CHANGES AS SUBMITTED IN S4.55 -
UNDER REVIEW - MOD/2024/0225

1728 Fortis South Steyne

34-35 South Steyne Manly NSW

GA Plans
Basement 1 Plan

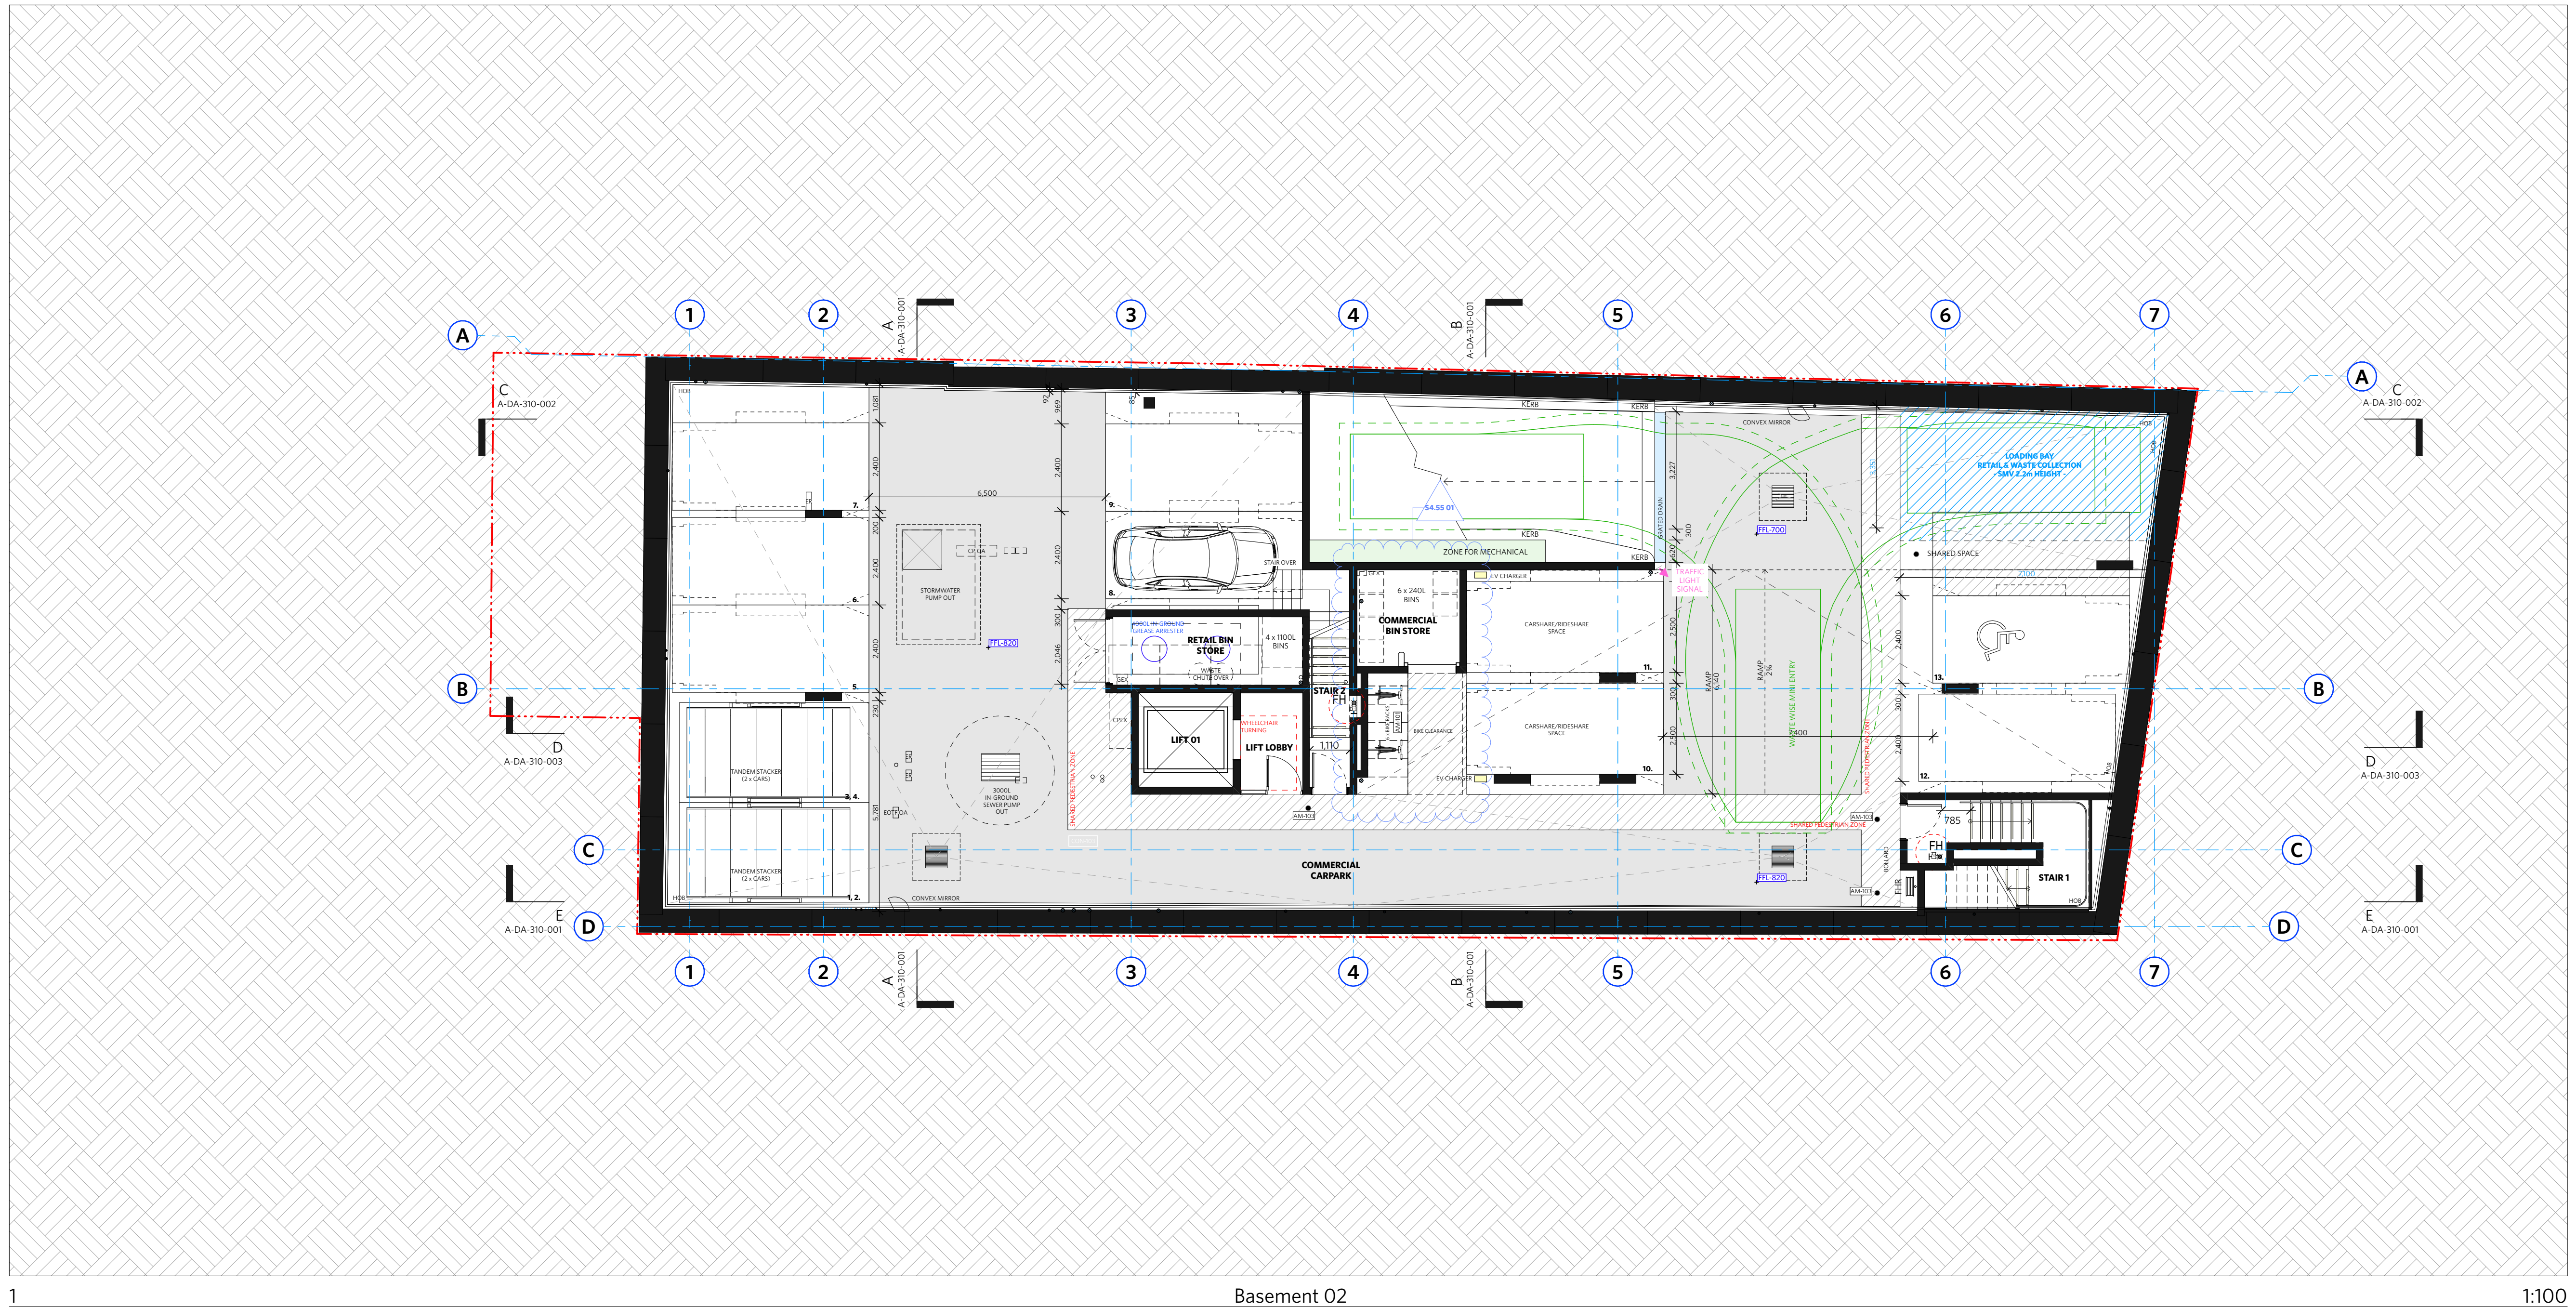
REV	CHANGE	DESCRIPTION
DA-J	20	Relocation of Sprinkler & booster alarm valves to fire stair 02

GA Plans
Ground Plan

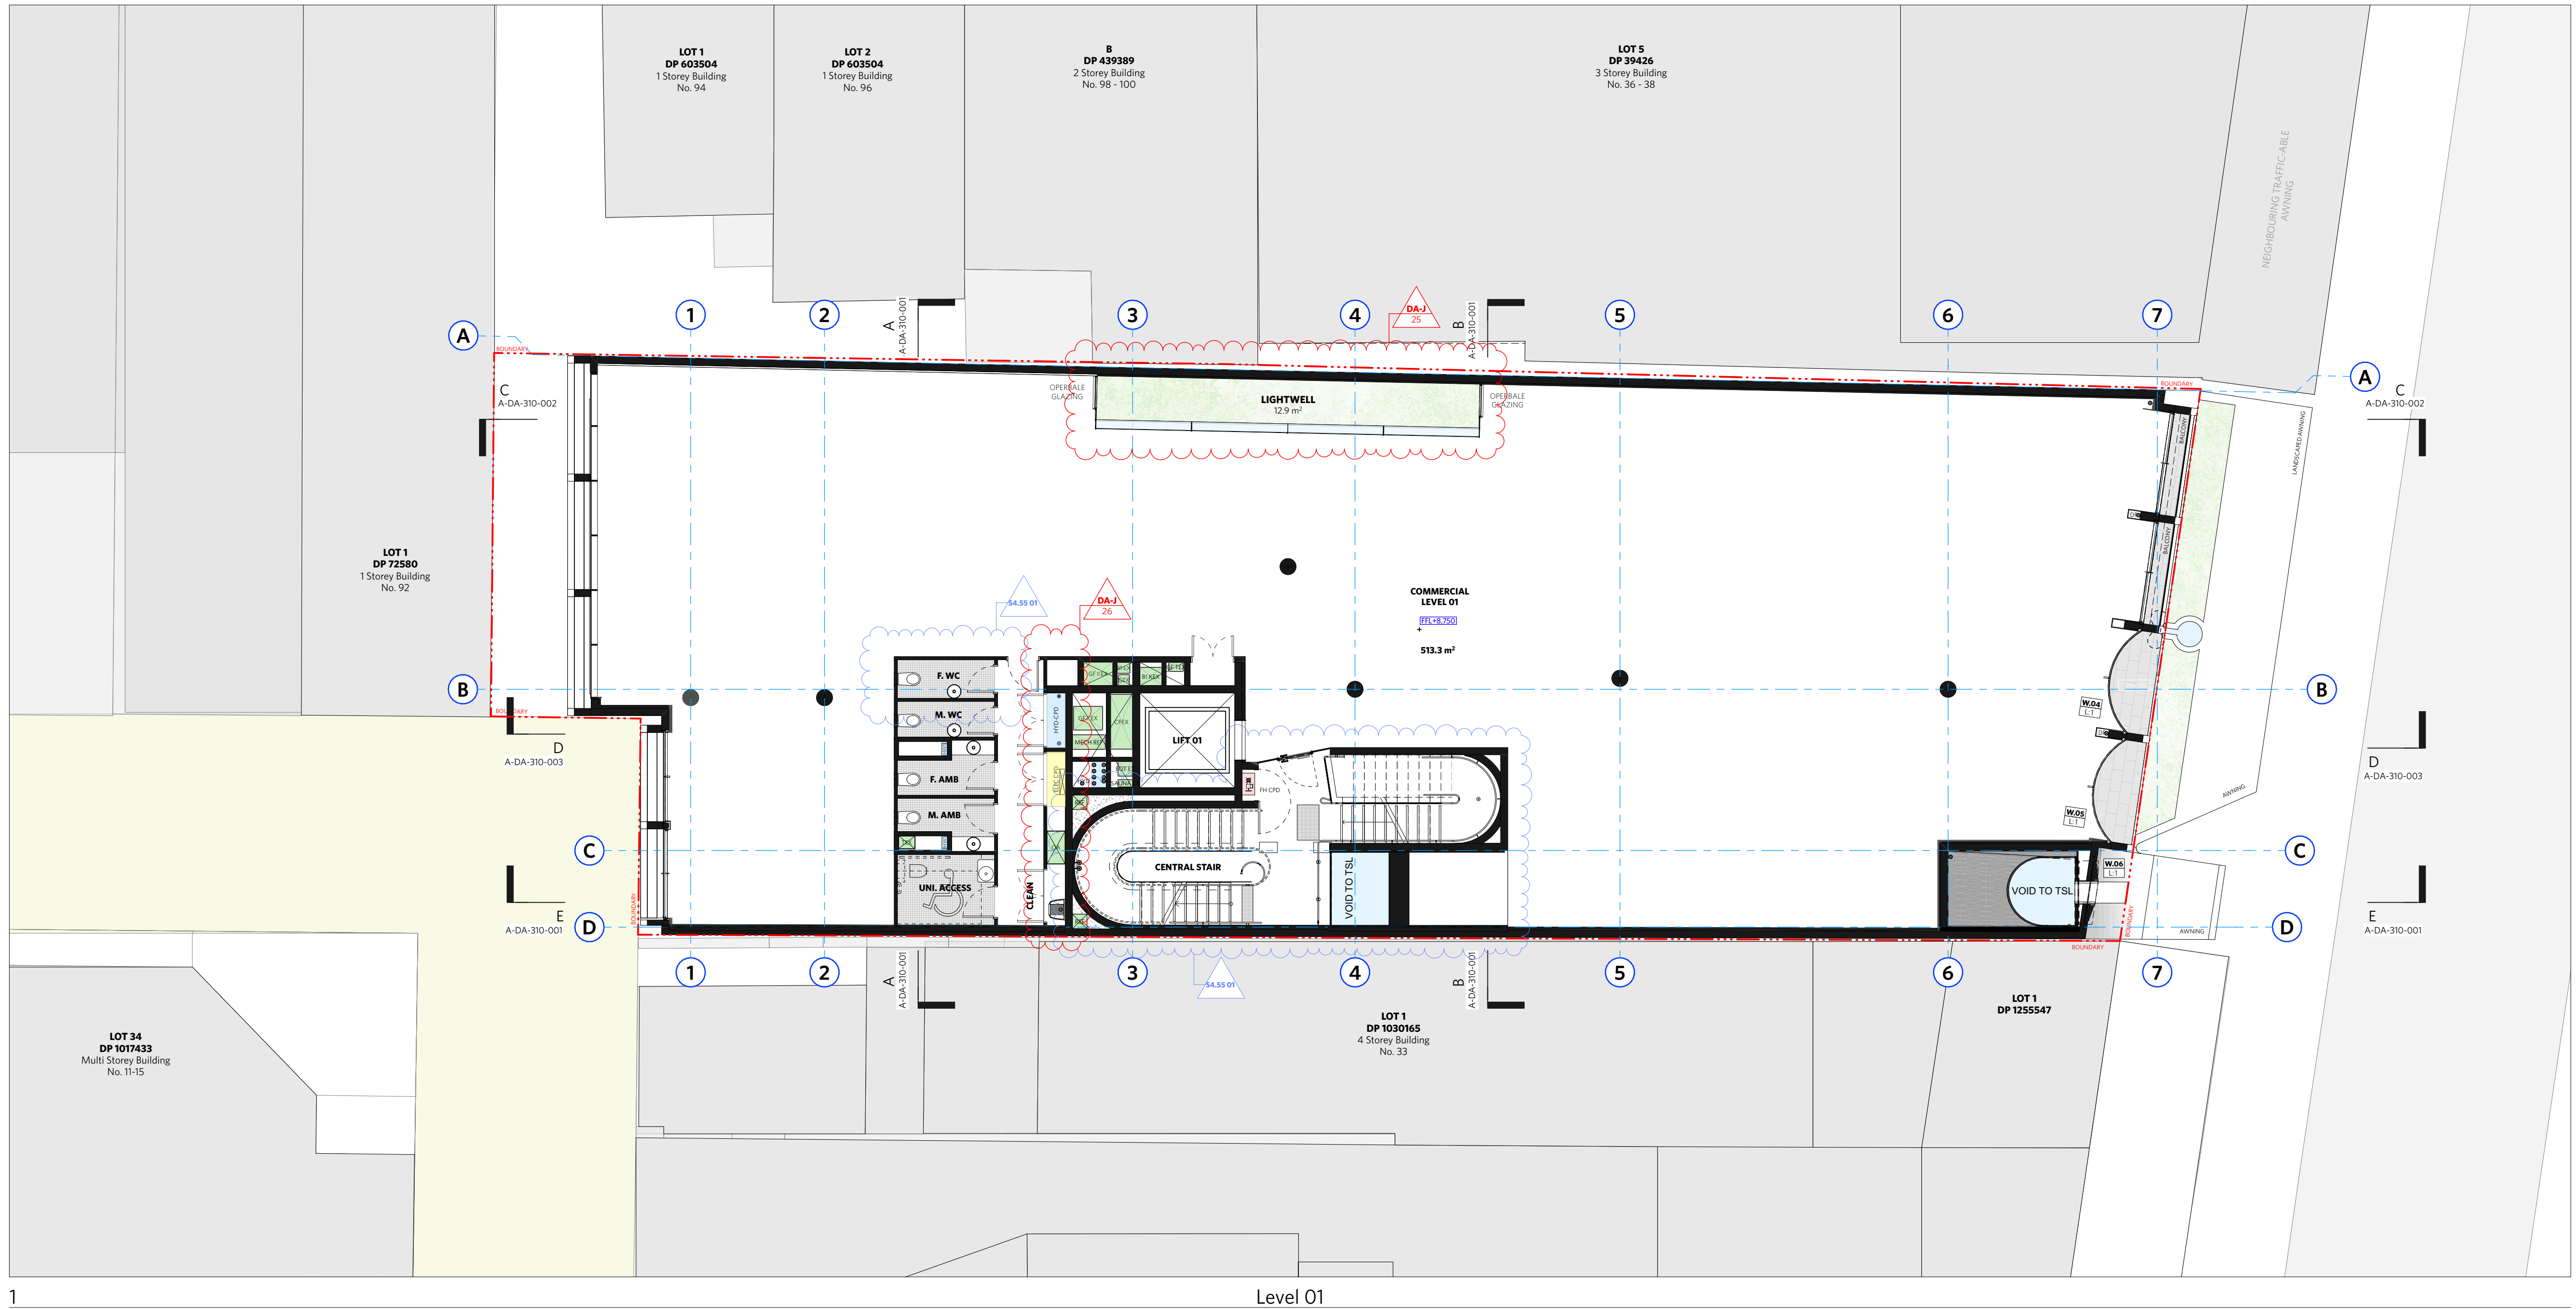
REV	CHANGE	DESCRIPTION
21	DA-J	Additional openings added into Ground floor Tenancy
22	DA-J	Relocation of Sprinkler Booster to South Steyne
23	DA-J	Sliding Fire Door Added to Through Site Link
24	DA-J	Removed flood barrier & replaced with passive flood barrier

DRAWN	CHECKED	DATE DRAWN	PRINTED
		24/07/01	18/7/2024 11:48 am
SCALE			
1:100 @ A1 / 1:200 @ A3			
TITLE			
GA Plans Level 3 Plan			
PROJECT NO.			
1728			
ISSUE			
DA			
REV			
DA-J			
DRAWING NO.			
A-DA-110-006

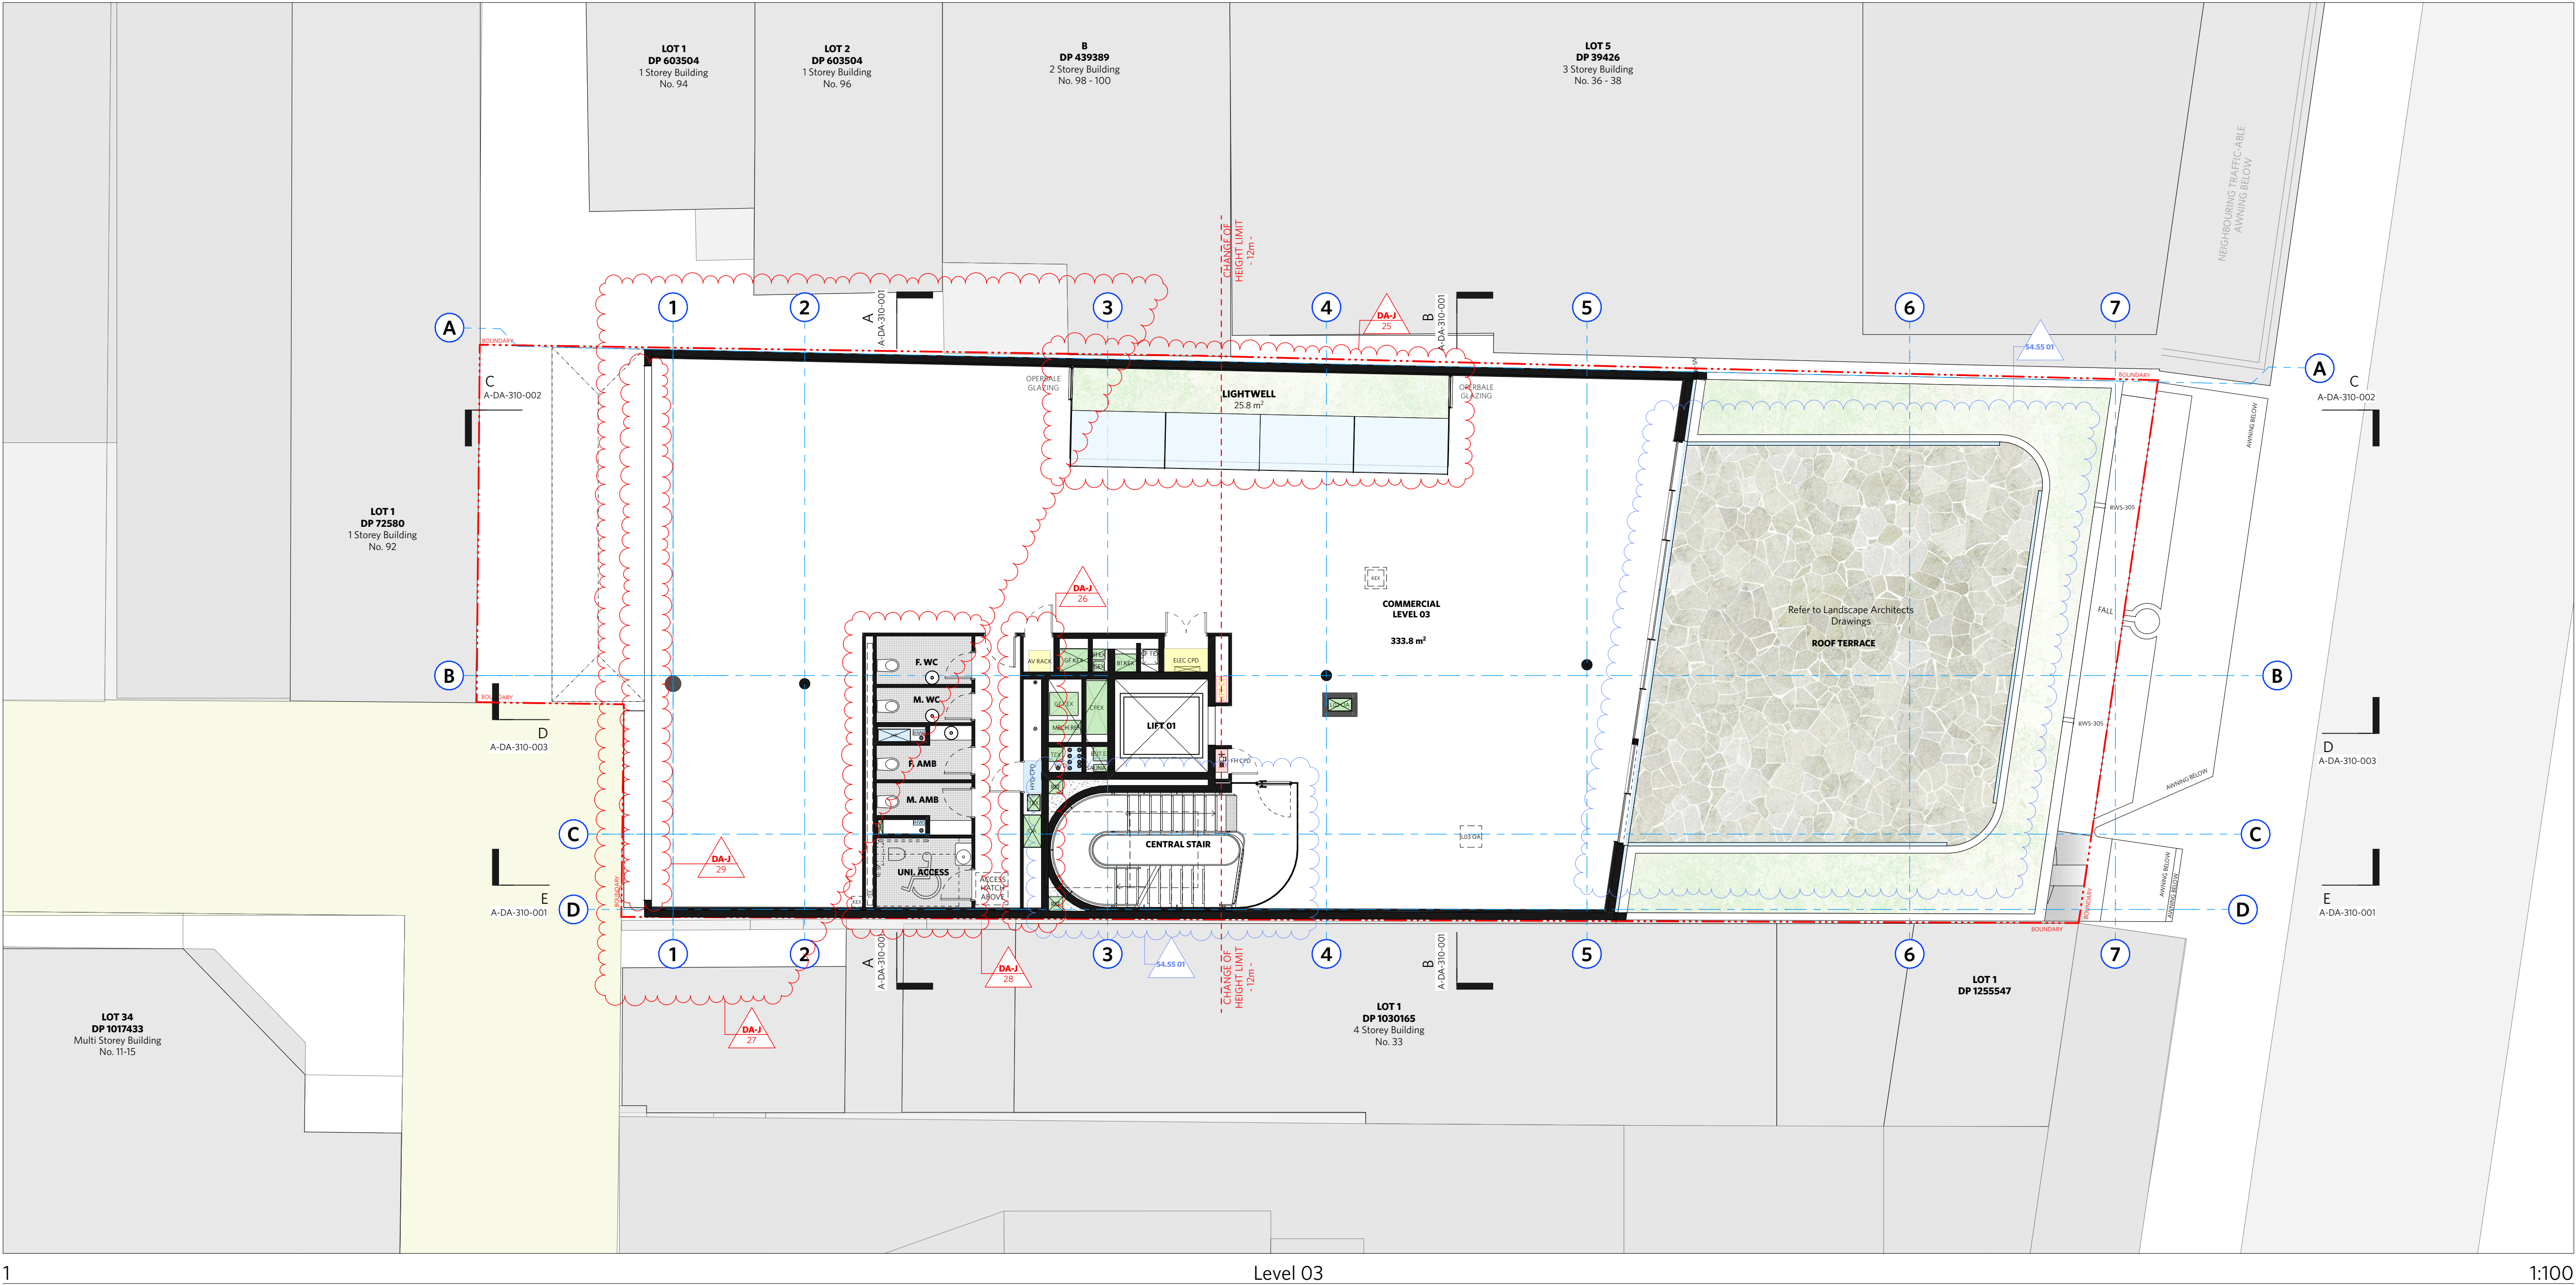
CHANGE SUMMARY		
REV	CHANGE	DESCRIPTION
25		Changes to the Central Courtyard
26		Minor Modifications to Core Layout
27	DA-J	Increase in Floor Space to the west
28		Changes to the Amenities to suit revised floor plate
29		Changes to window openings to the west to suit new form
